CITY OF NEWTON, MASSACHUSETTS PURCHASING DEPARTMENT

ADDENDUM #2 INVITATION FOR BID #24-01

GATH MEMORIAL POOL IMPROVEMENTS PROJECT

THIS ADDENDUM IS TO: CHANGE PROJECT MANUAL AND MAKE DRAWINGS CHANGES.

A801 LAP POOL PLAN

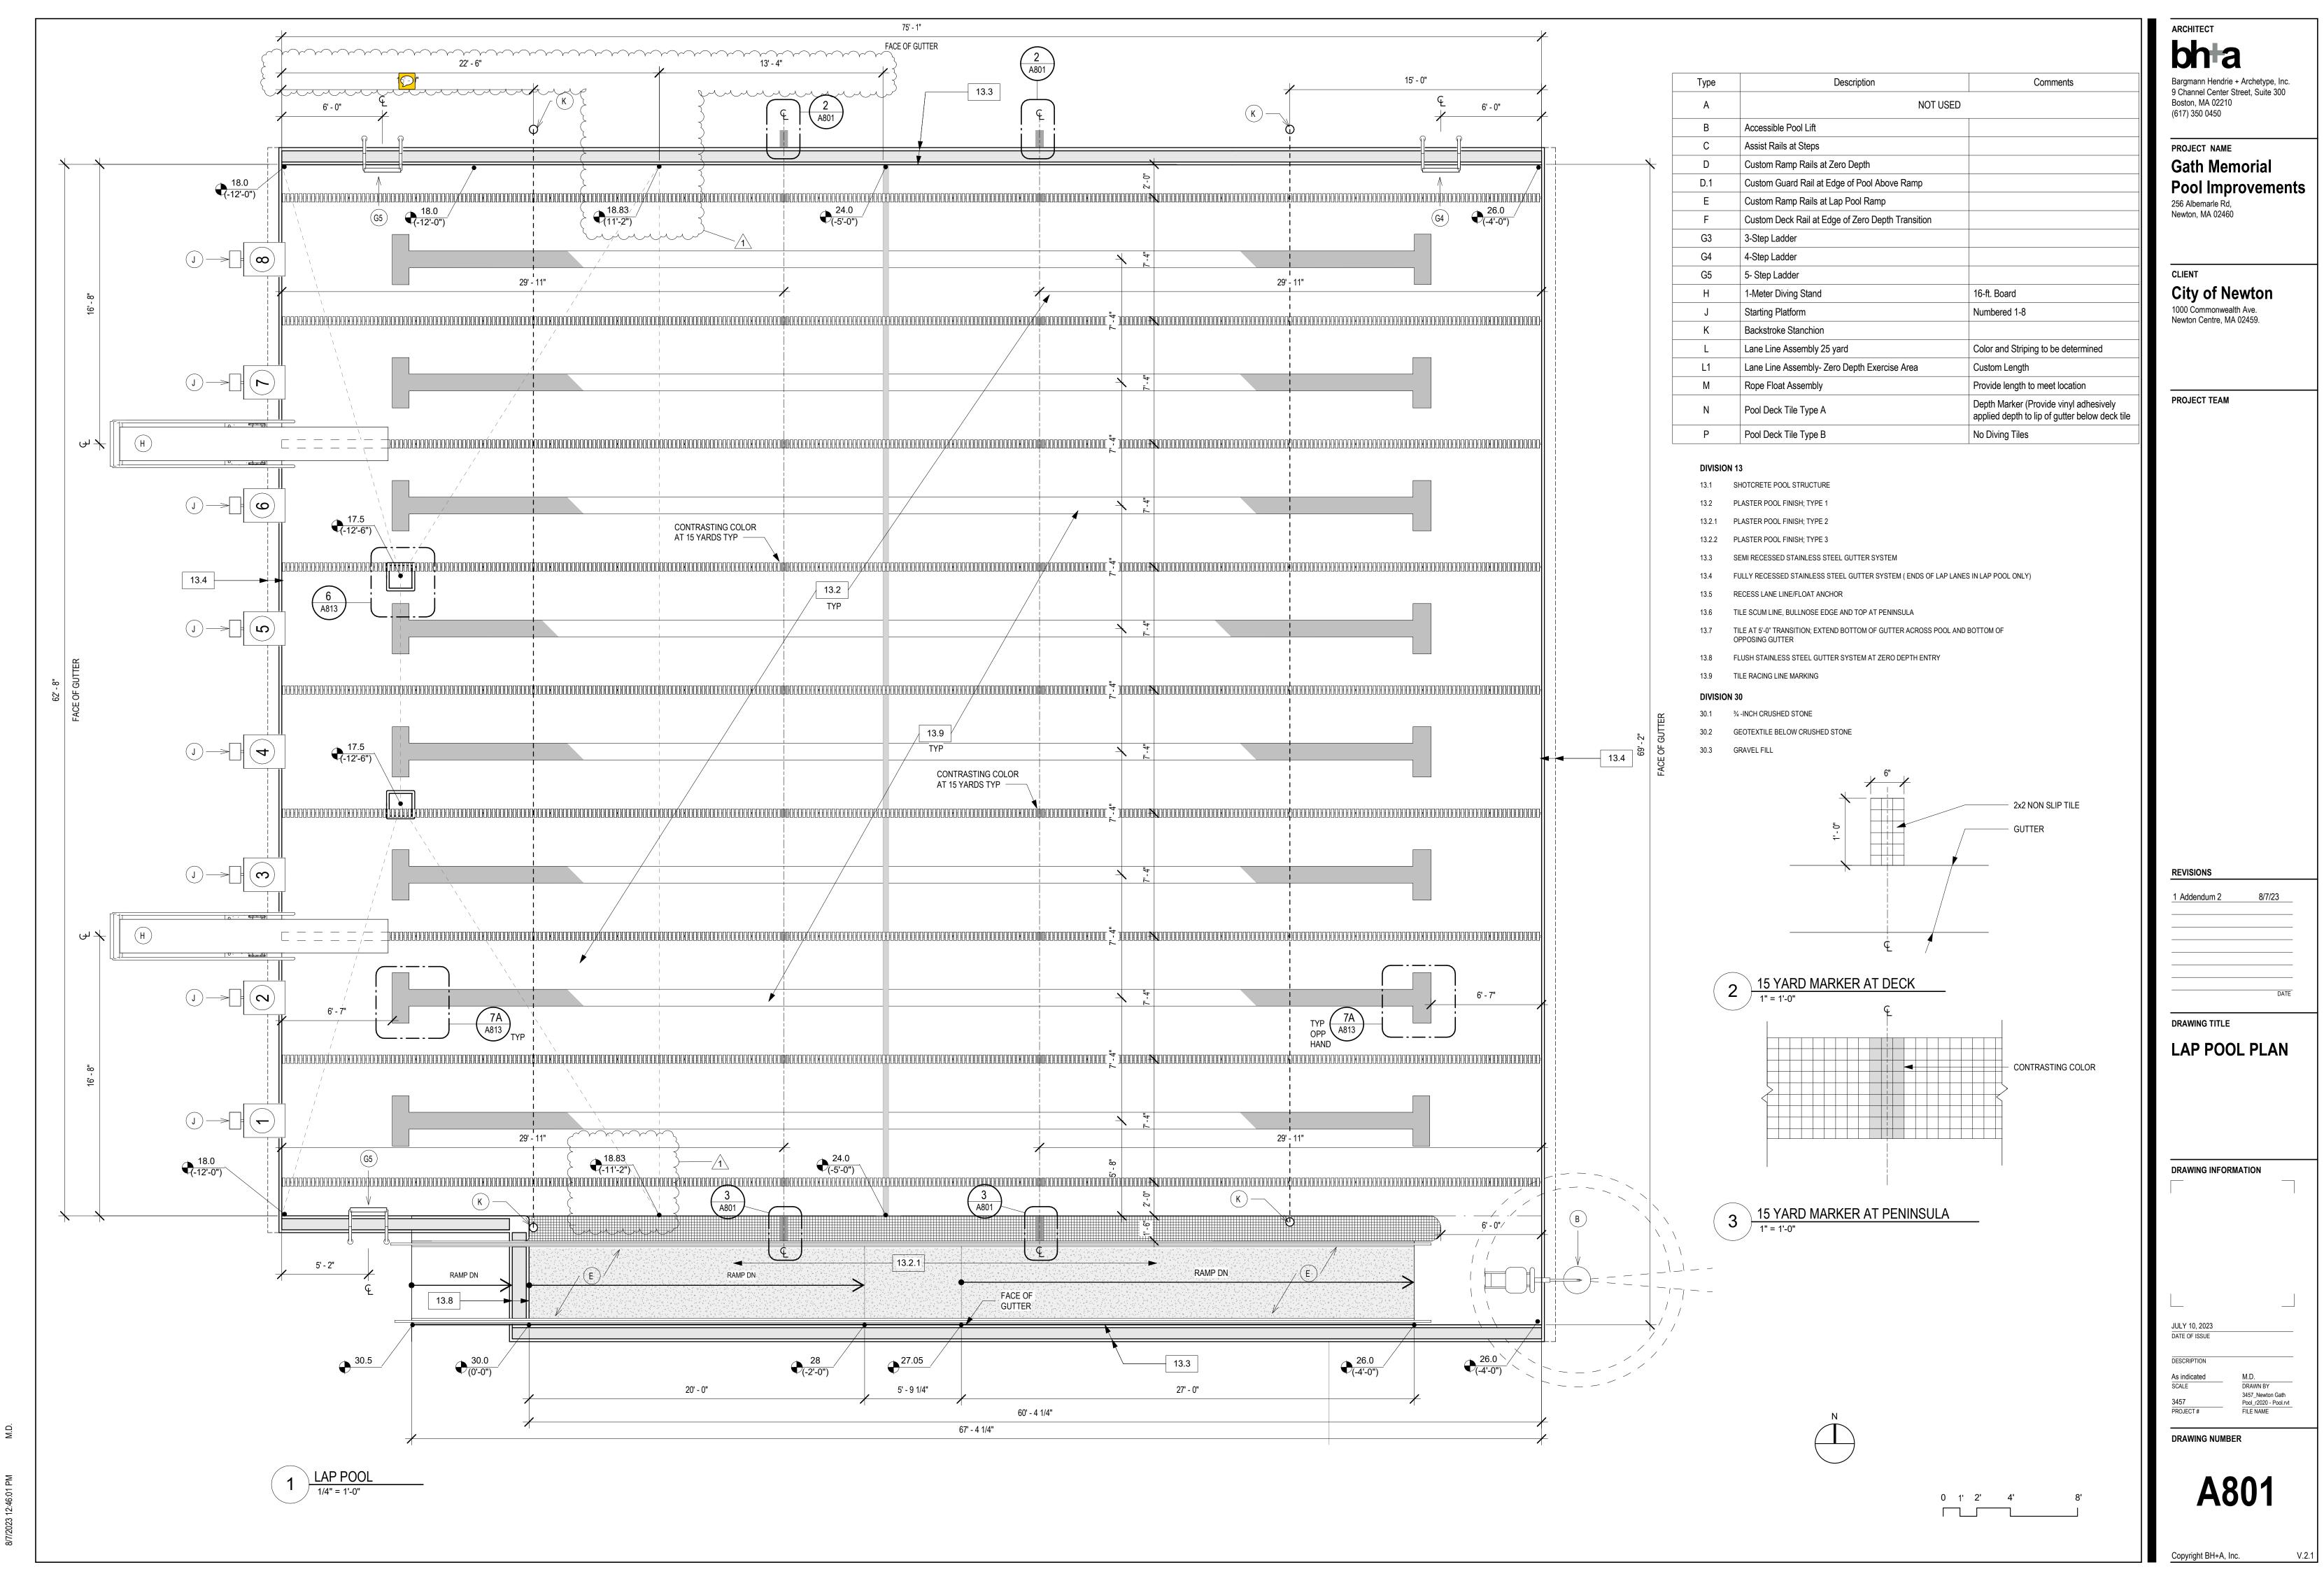
• Remove and insert revised Sheet A801

Scope: Minor adjustment to pool depth; adding dimensions to pool floor.

A802 ZERO DEPTH POOL PLAN

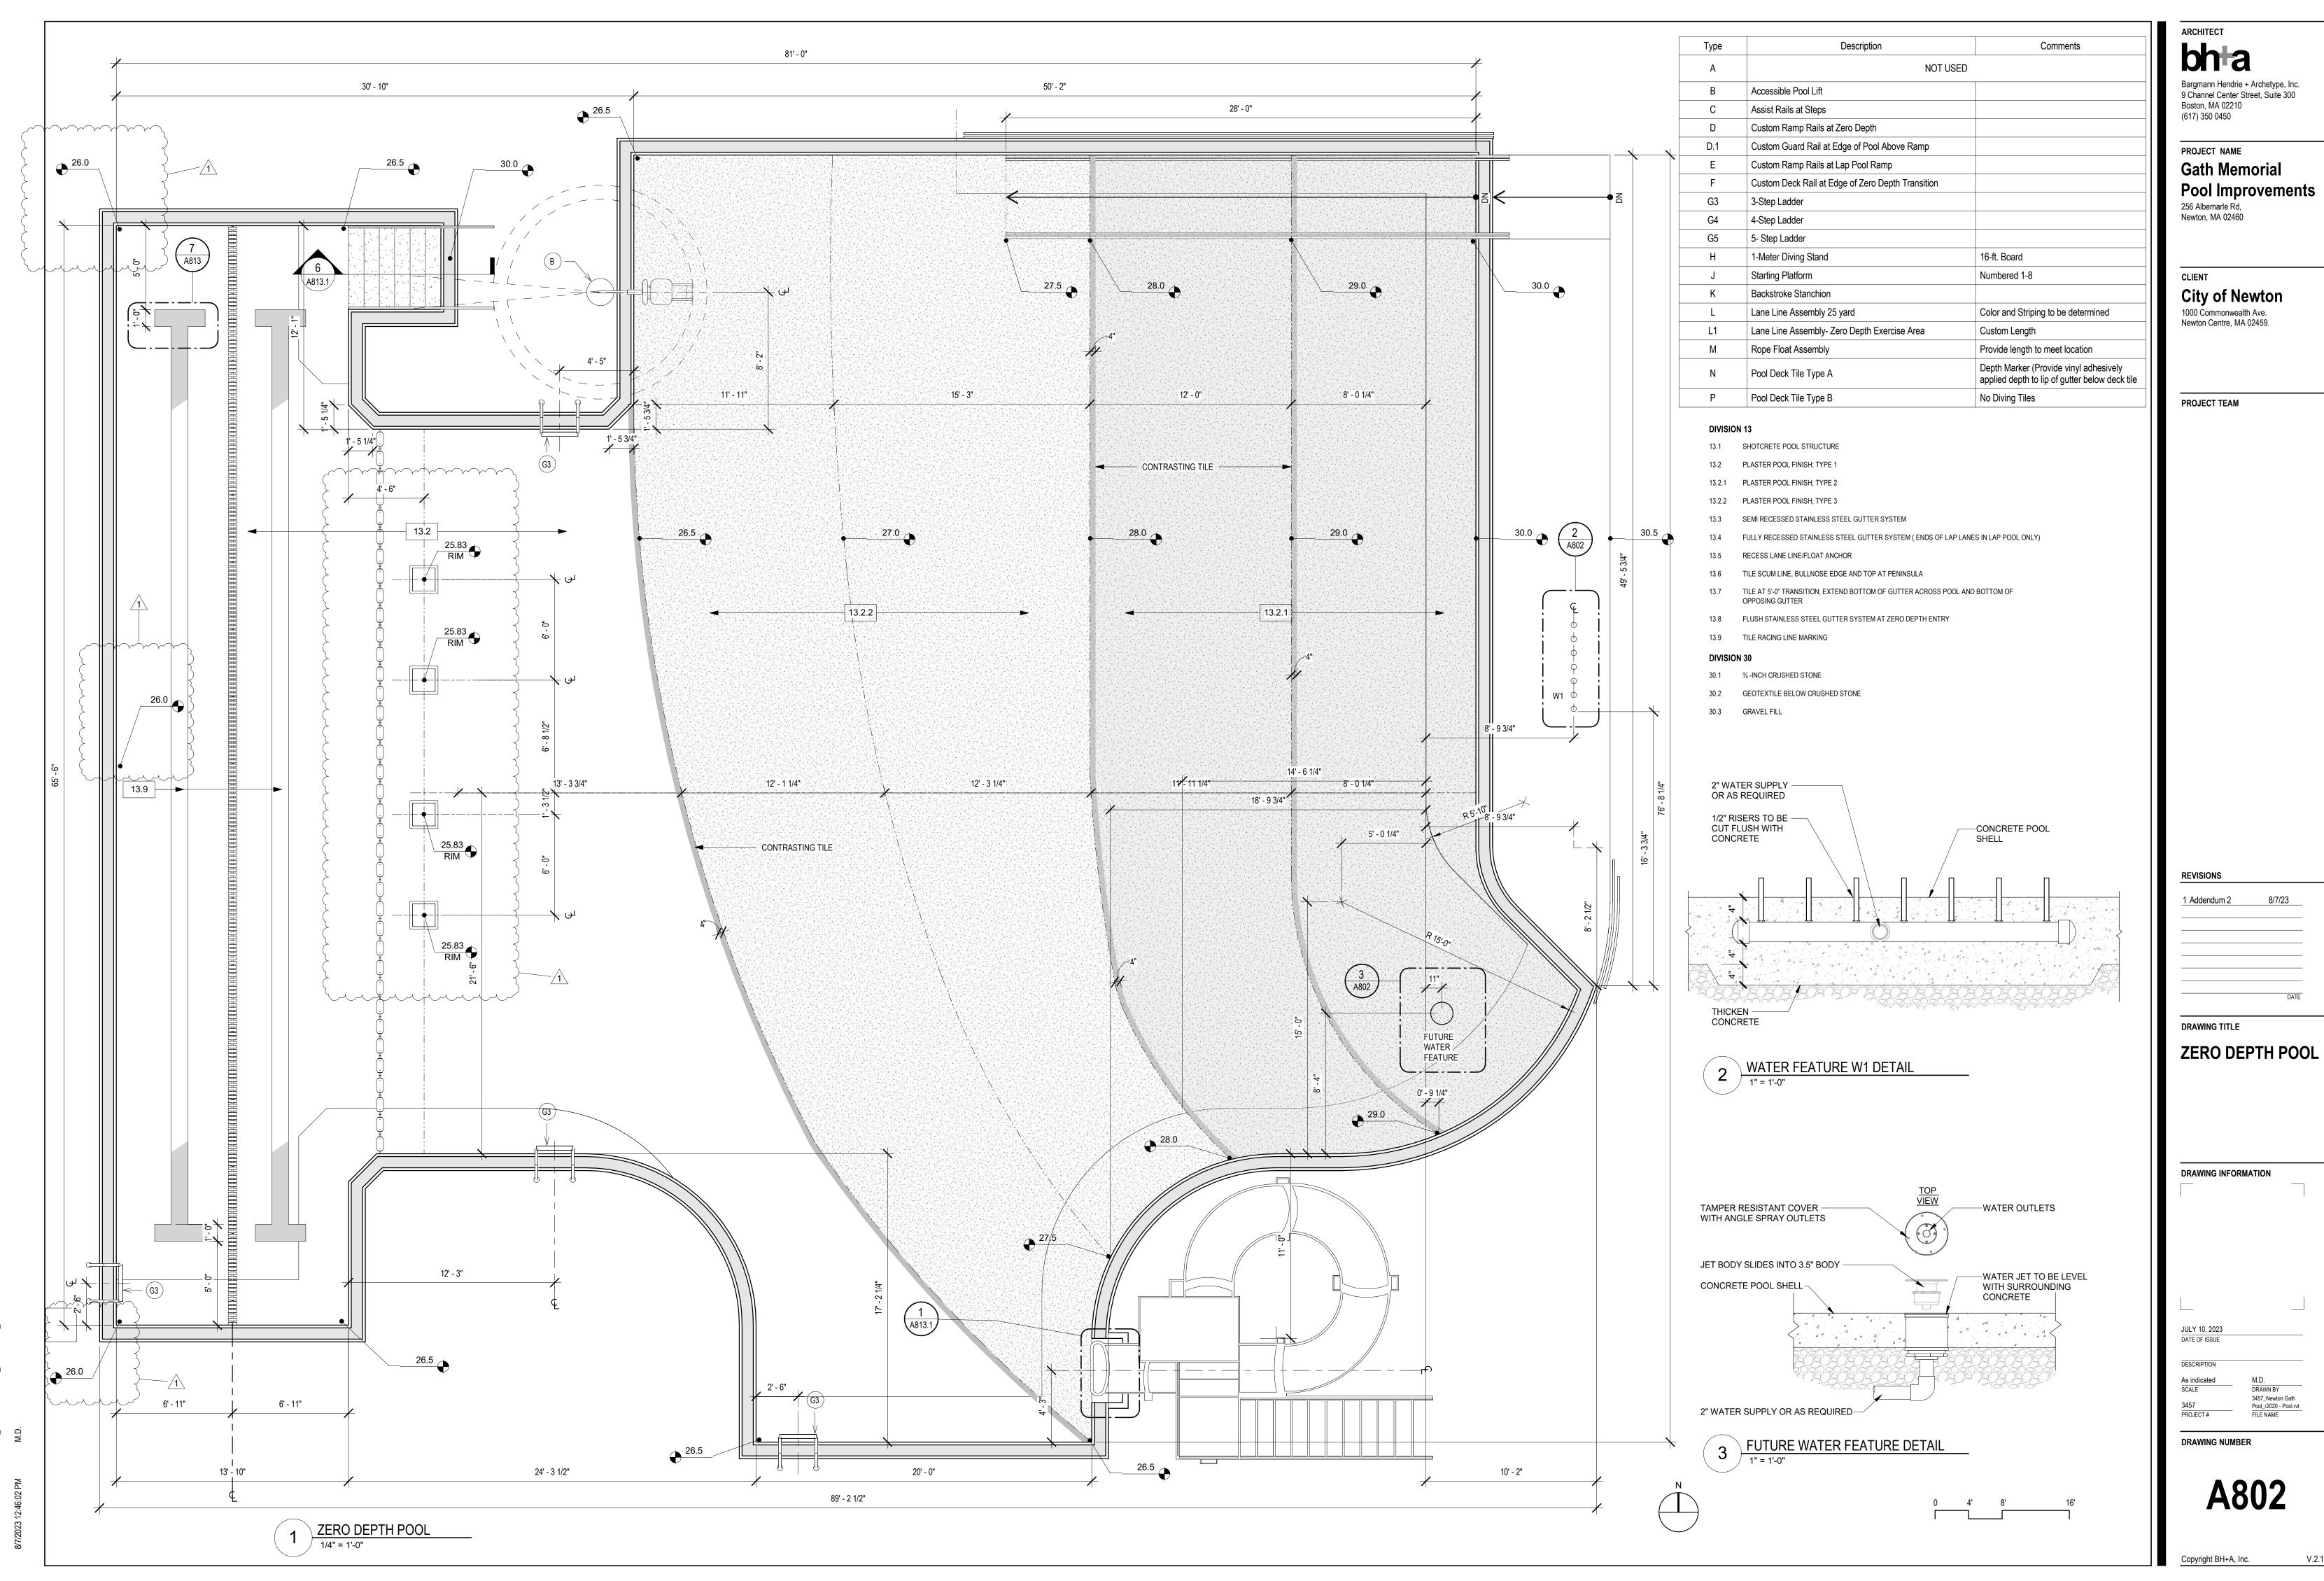
• Remove and insert revised Sheet A802

Scope: Minor adjustment to pool depths at west edge of pool in walking lanes; relocation of main drains

A813 POOL DETAILS

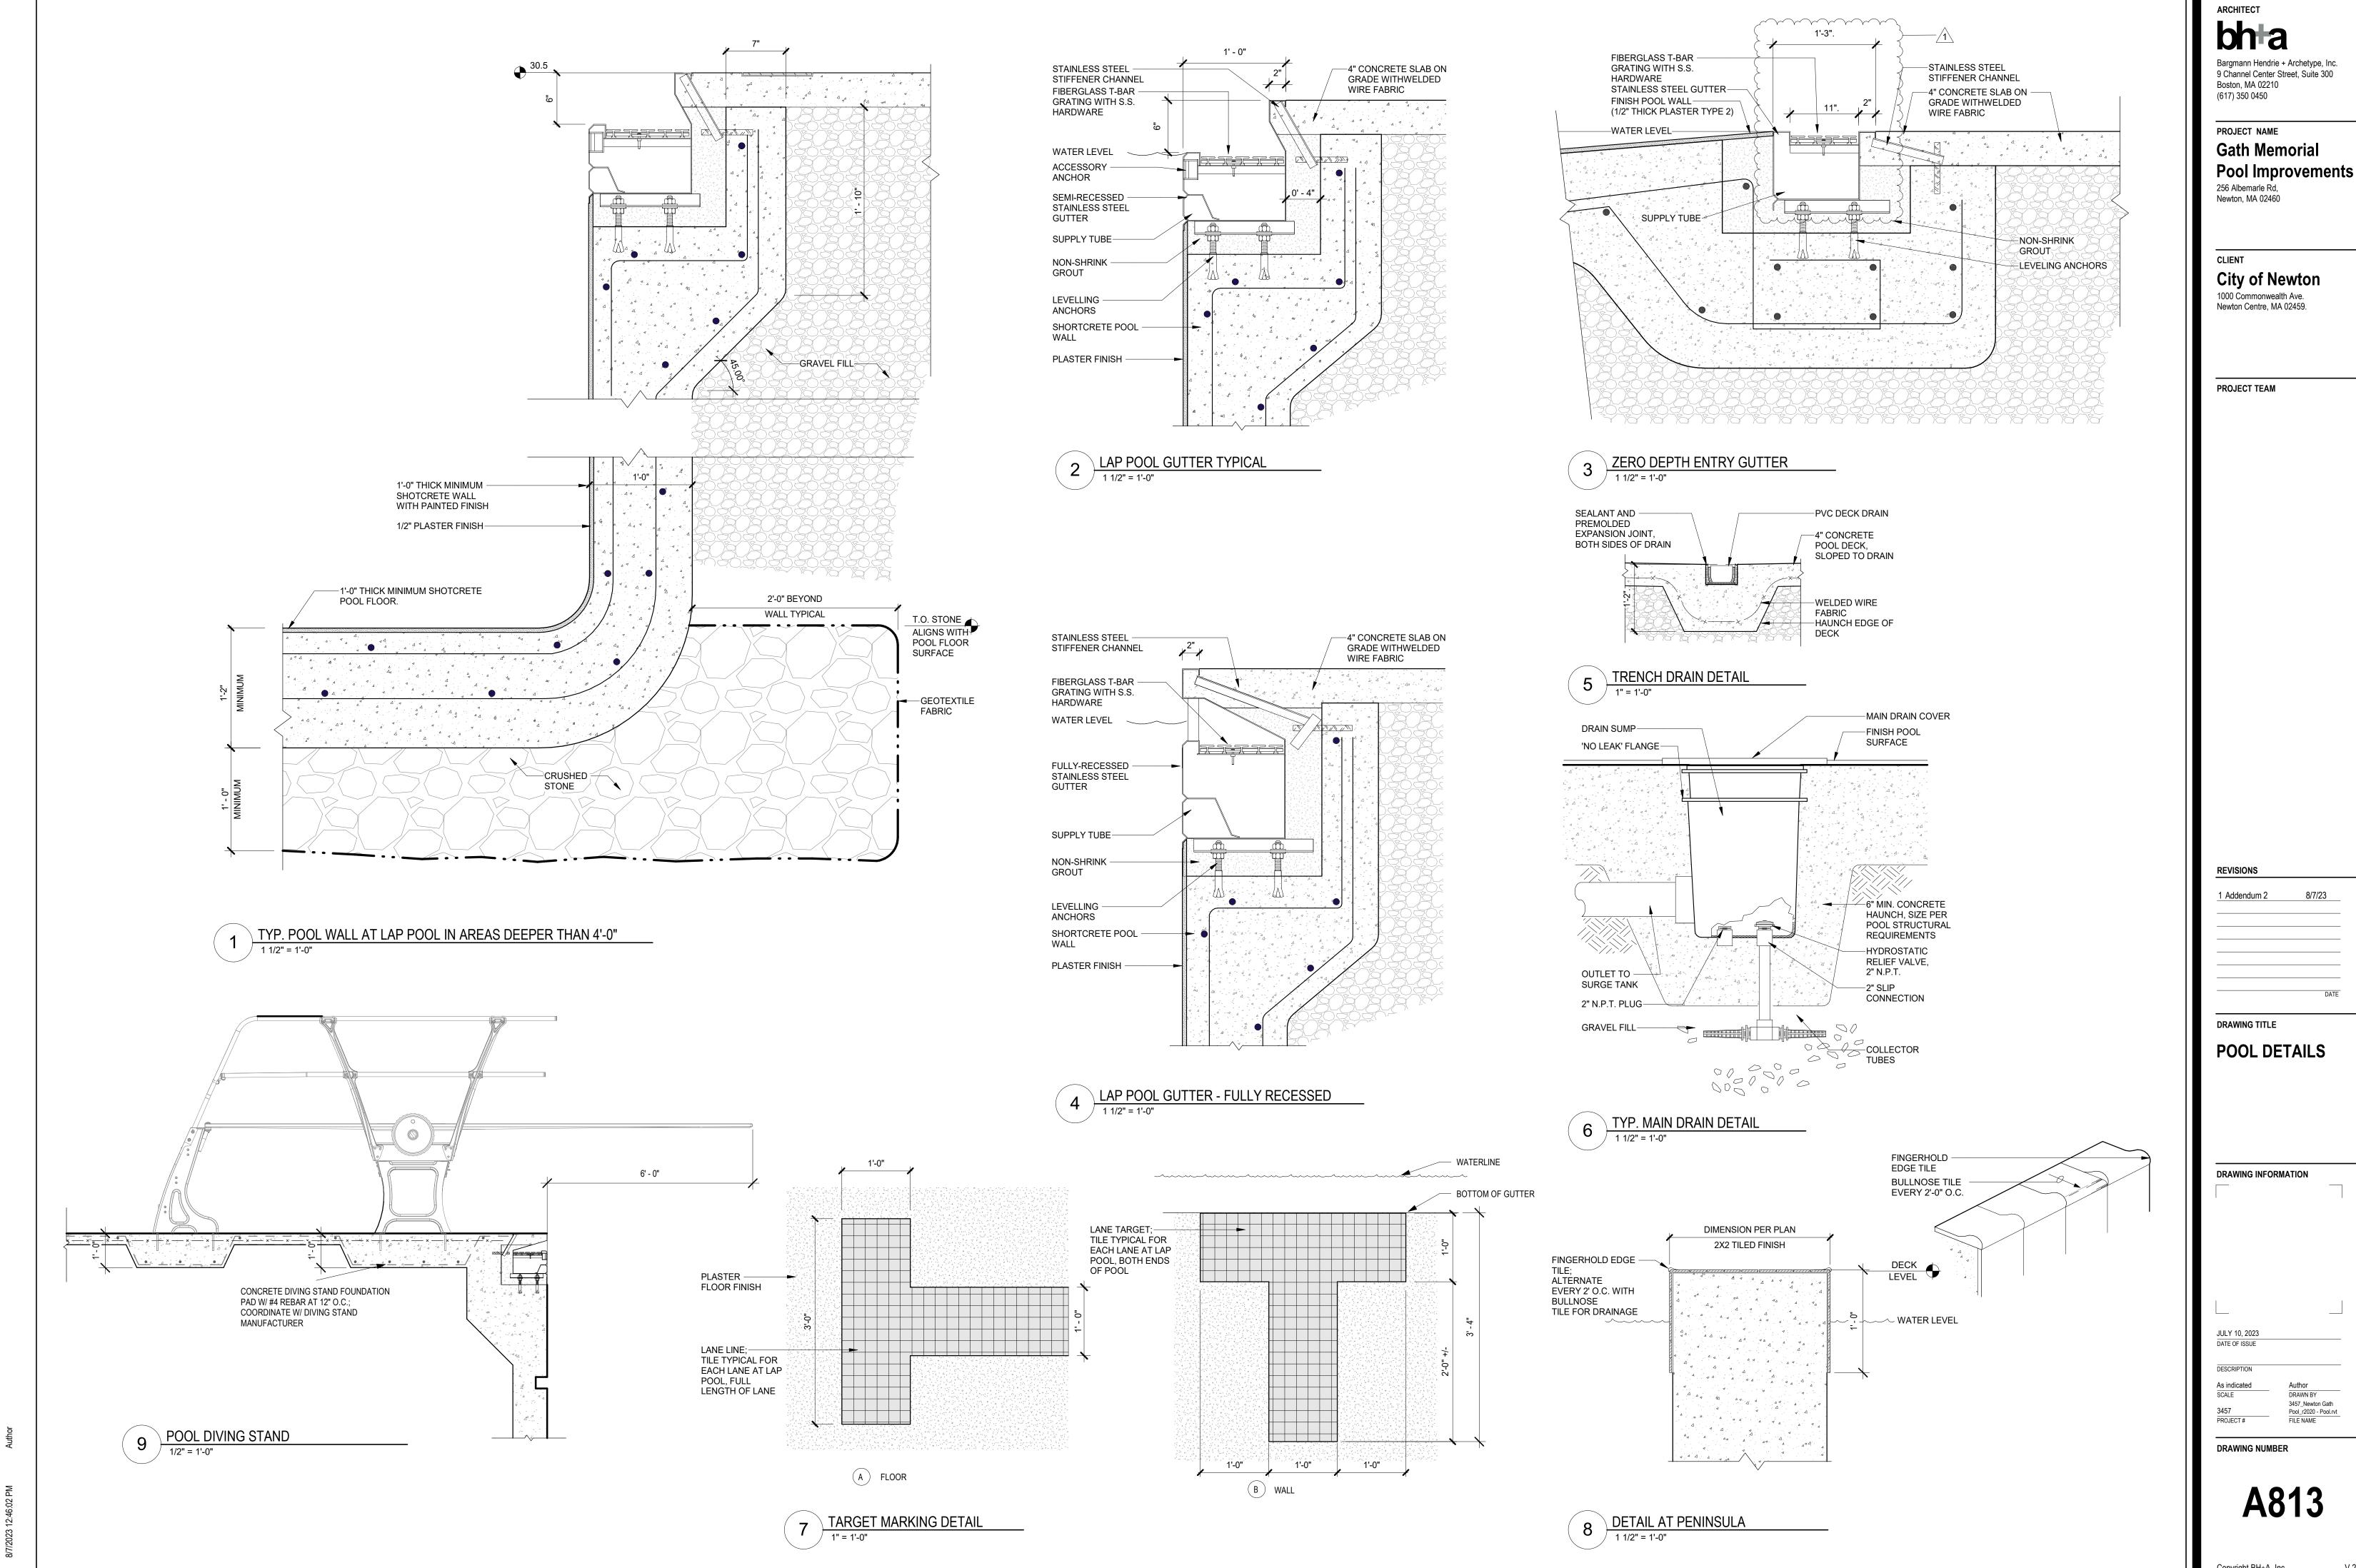
• Remove and insert revised Sheet A813

Scope: Correction of Gutter Profile at Zero Depth Entry Detail 3.
